BRAKES—REDUCED POWER ASSIST DURING OPERATION IN FREEZING AMBIENT TEMPERATURES—LIGHTNING MODELS ONLY	Article No. 01-25-5

FORD: 1999-2001 F-150

Figure 1 - Article 01-25-5

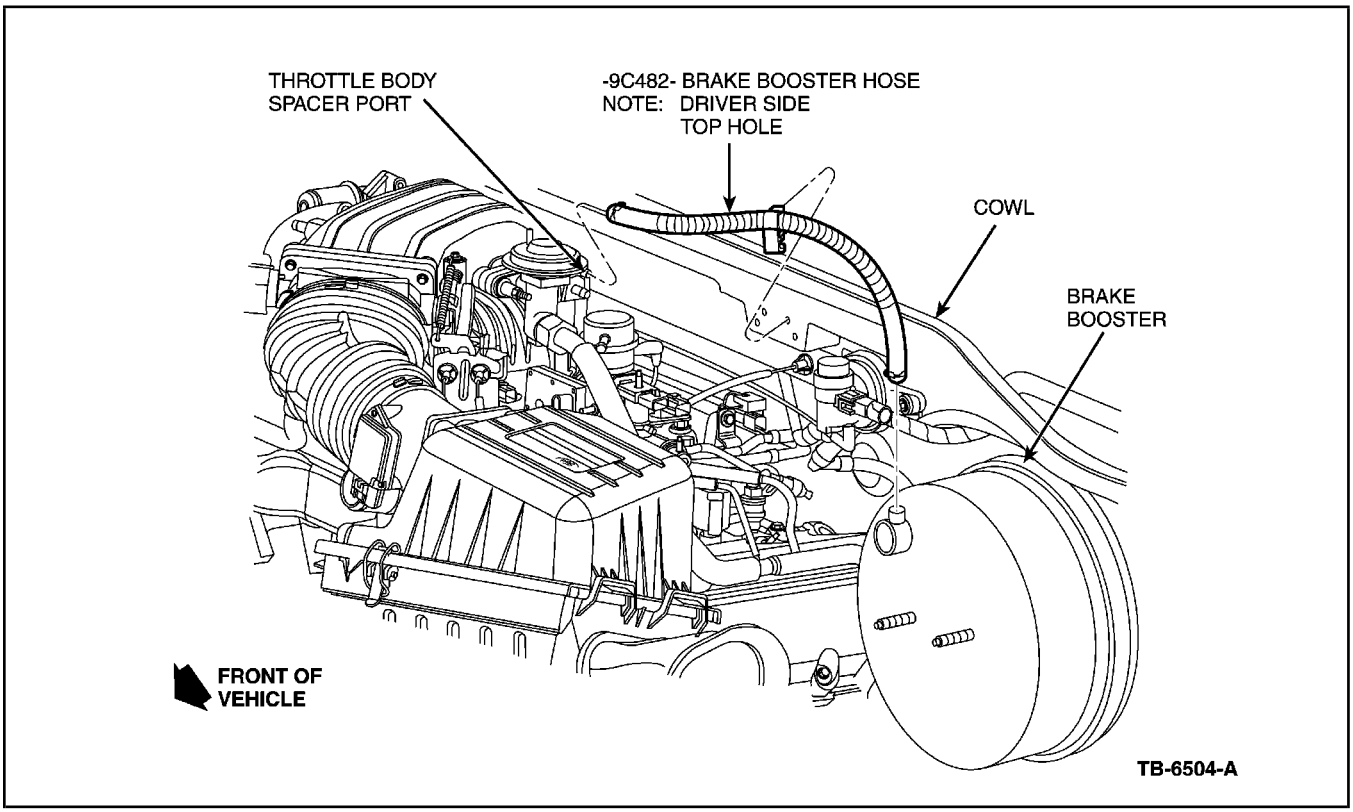
Some Lightning model vehicles may exhibit a reduced power assist after the first two or three brake applications during operation in freezing ambient temperatures. This may be caused by current production routing of the brake booster vacuum hose allowing water to collect in the hose which can freeze in cold ambient temperatures.

1. Remove existing brake booster hose and discard.
2. Install new brake booster hose (1L3Z-9C482-AA). Secure new hose by inserting retainer (included) into the upper hole on the driver's side of the cowl trim panel (Figure 1).
3. Road test and verify brake effectiveness.
